# HOWARD COUNTY HISTORIC PRESERVATION COMMISSION

## January Agenda

### HPC-18-62 – 3531 Sylvan Lane, Ellicott City

**HPC-18-63 – 5819 Lawyers Hill Road (6219 Lawyers Hill Road per design guidelines map), ElkrIDGE**

Figure 1- Aerial of existing structure

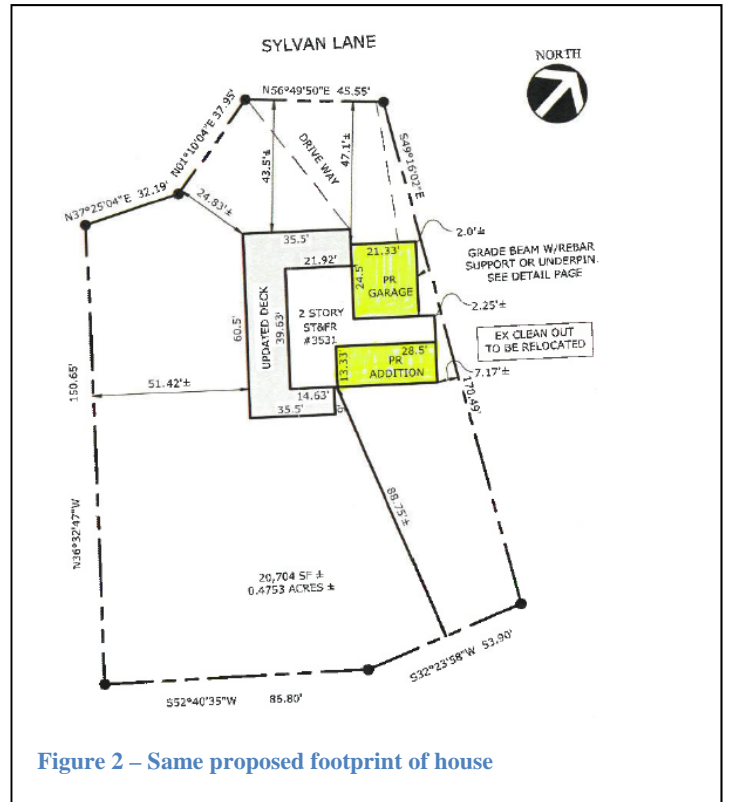
The application explains that the Applicant proposes to construct a new front entry and porch on the north side of the housing facing the street, as the current entry is located on the west side of the house due to ADA access for the previous owner. However, after visiting the site, Staff finds the west side of the house is the original front of the house and was most likely designed that way to take advantage of views of the Patapsco River. The details on the porch, such as the wide columns (including base and capital) and brick piers, appear to be original components of the house. The location of the center dormer above the porch are also indicative of the front of a Craftsman/bungalow style house.

The Commission should determine which side they find to be the actual front of the home, as all elements and alterations from this point out are determined by which side is considered the front.

**Staff Recommendation from December 6, 2018:** Staff recommends this application be amended to Advisory Comments, with the following recommendations for the Commission to consider:

Figure 11 - Location of preserved land in Lawyers Hill

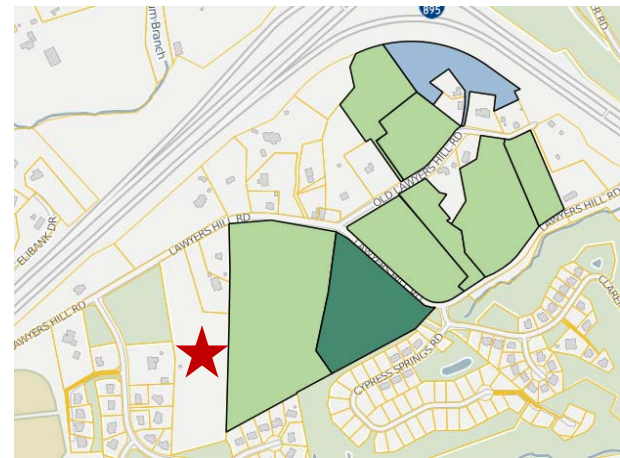
This goal has been supported through voluntary land easements that many property owners have added over the years. The easements in Lawyers Hill include Rockburn Land Trust easements, Conservation easements, Maryland Environmental Trust easements and Maryland Historical Trust easements (easements are shown in Figure 11 in green and blue, and the subject property is shown with a red star).
